SERVICE BULLETIN

TITLE: Repair or reinforcement of Rudder Skins
at Tab Hinge

BULLETIN NO. 258

MODELS AFFECTED: 108-3 Serial Numbers 108-3502
thru 108-4930

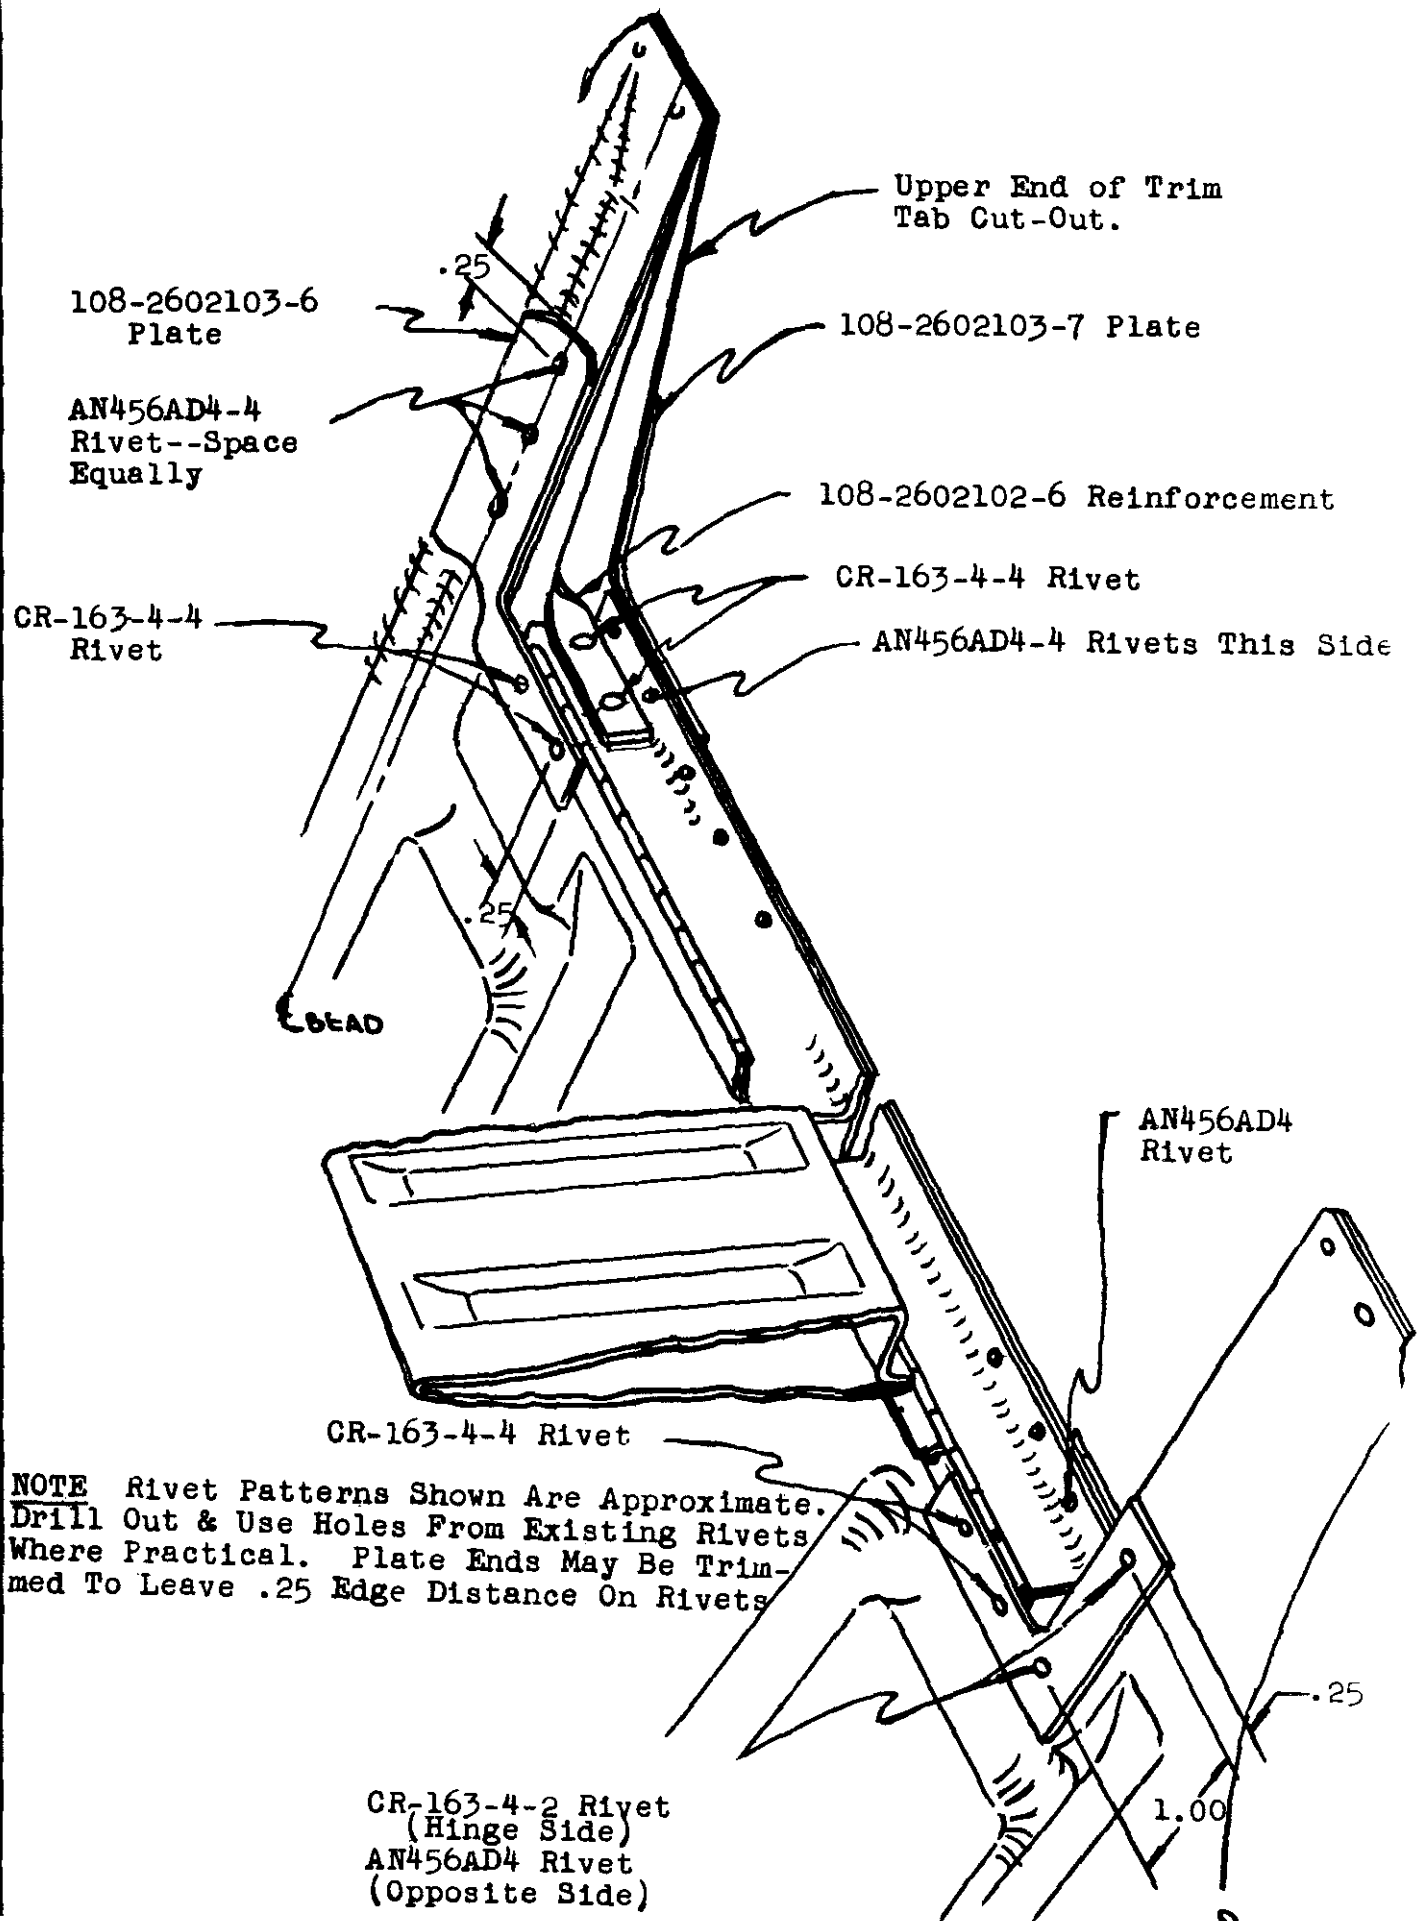
A. Inspect rudder skins at points immediately adjacent to the upper and lower ends of the rudder tab hinge for cracks. If cracks are not present, we recommend the installation of reinforcement, part number 108-2602102-6, to preclude the possibility of cracking. This reinforcement is installed at the factory on airplanes bearing serial number 108-4931 and up. Installation instructions follow:

1. Detach rudder tab flexible shaft at tab end.
2. Position reinforcement, part number 108-2602102-6, as shown on drawing on page 3.
3. Attach reinforcement to rudder with two (2) Cherry Rivets CR-163-4-4 through rudder false spar and one (1) Brazier Head Rivet AN456AD4-4 through rudder skins at center of bead.
Drill .128 diameter holes for rivets.

1. Detach rudder tab flexible shaft at tab end.
2. Install reinforcement, part number 108-2602102-6, as outlined in paragraph A. above, EXCEPT DO NOT INSTALL AN456AD4-4 rivet through rudder skins.

3. Drill #40 (.098 dia.) stop hole at end of cracks in rudder skins.
4. If the rudder skin is cracked on the tab hinge side, drill out the top two rivets which attach the tab hinge to the rudder. If the skin is cracked on the side opposite the tab hinge, drill out the two top rivets on that side. Naturally, if the skins are cracked on both sides, all four rivets must be removed.

5. Install reinforcement plate, part number 108-2602103-6, over crack on tab hinge side and plate, 108-2602103-7, over crack on opposite side.
6. Drill .128 diameter holes through plate (or plates) to pick up holes from drilled out rivets. Drill .128 hole through plate (or plates) at center of skin bead. Drill additional hole through plate (or plates) so as to have three holes equally spaced on the centerline of the skin bead.

7. Attach plate (or plates) with three Brazier Head rivets AN456AD4-4 through skin beads. Use two (2) Cherry Rivets CR-163-4-4 to attach plate to hinge side of rudder and two (2) Brazier Head rivets AN456AD4-3 on opposite side.

C. Where cracked rudder skins are found adjacent to the lower end of the tab hinge, the following repairs should be made:

1. Drill a #40 (.098) stop hole at the end of the crack.
2. If the rudder skin is cracked on the tab hinge side, drill out the two bottom rivets which attach the tab hinge to the rudder. If the skin is cracked on the side opposite the tab hinge, drill out the two bottom rivets on that side. Naturally, if the skins are cracked on both sides, all four rivets must be removed.

3. On most 108-3 models another rivet was installed directly below the rivets mentioned above. If this rivet is present, it must also be drilled out.
4. Position reinforcement plate, part number 108-2602103-10, and drill .128 diameter holes through plate to pick up holes from drilled out rivets. If the rivet mentioned under item 3 was not present it will be necessary to drill another .128 hole - see drawing. Drill a fourth .128 hole as shown on drawing.

5. Attach plate on hinge side with two Cherry Rivets CR-163-4-4 through plate and hinge. Use Brazier Head rivets AN456AD4-3 in all other holes and for attaching reinforcement plate on side opposite tab hinge.

NOTE Rivet Patterns Shown Are Approximate. Drill Out & Use Holes From Existing Rivets Where Practical. Plate Ends May Be Trimmed To Leave .25 Edge Distance On Rivets
